FINAL  
SUPPLEMENTAL ENVIRONMENTAL IMPACT STATEMENT

SEWAGE EFFLUENT COMPLIANCE PROJECT  
LOWER SANTA MARGARITA BASIN  
MARINE CORPS BASE CAMP PENDLETON  
SAN DIEGO COUNTY, CALIFORNIA

DECEMBER 1998

Figure 2-12

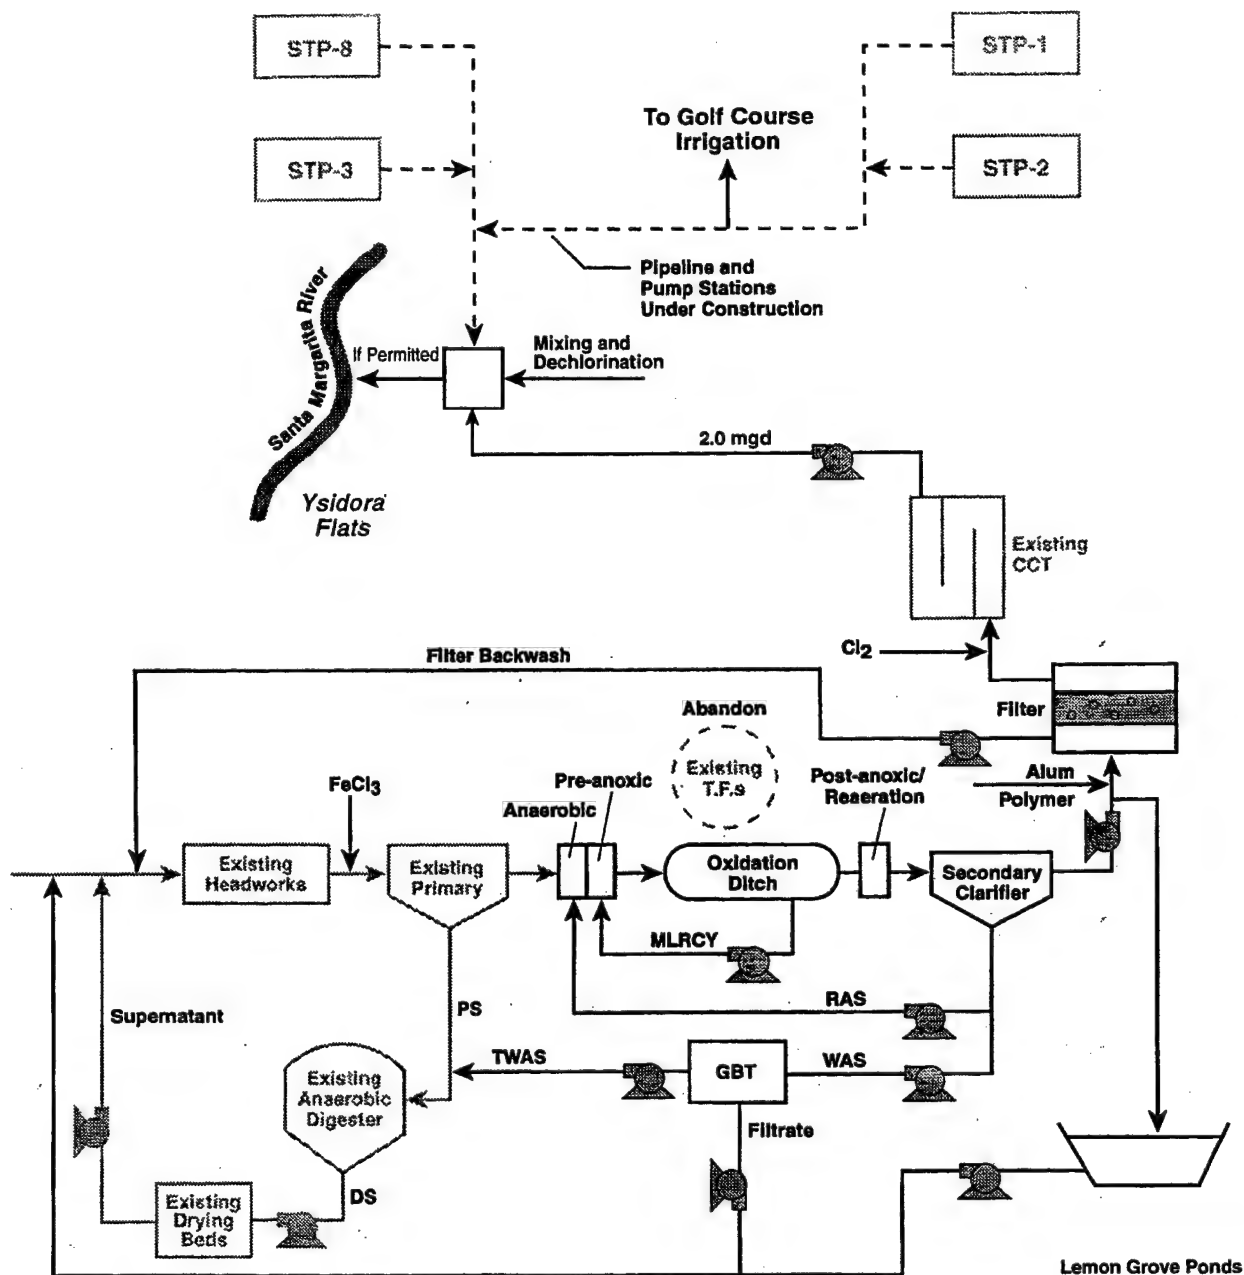
2	19	Figures 2-12 and 2-14, Schematic Flow Diagrams, respectively for alternatives 4 and 5, do not show dechlorination prior to groundwater injection. The FSEIS should indicate if this step would be included in either alternative.	Dechlorination is not proposed for alternatives 4 and 5 because chlorination is needed to prevent biomass accumulation in the proposed wells.
2	20	Figure 2-8, Alternative 2 Location of Phase 2 Facilities, and the accompanying text, do not clarify whether the pipeline between STP 2 and the proposed Ysidora discharge point is already constructed, authorized in the FEIS/R ROD, or a new proposal. The FSEIS should clarify this point.	Figure 2-10 and the accompanying text in Section 2.2.2 have been revised in the FSEIS to clarify that the pipeline from STP 2 to the Vandegrift Blvd. junction was authorized in the FEIS/R ROD. There is an existing pipeline from the junction to Ysidora Flats. Discharge to Ysidora Flats is no longer part of alternative 2.

Figures 2-12 and 2-13, Schematic Flow Diagrams, respectively for alternatives 4 and 5, do not show dechlorination prior to groundwater injection. The FSEIS should indicate if this step would be included in either alternative.
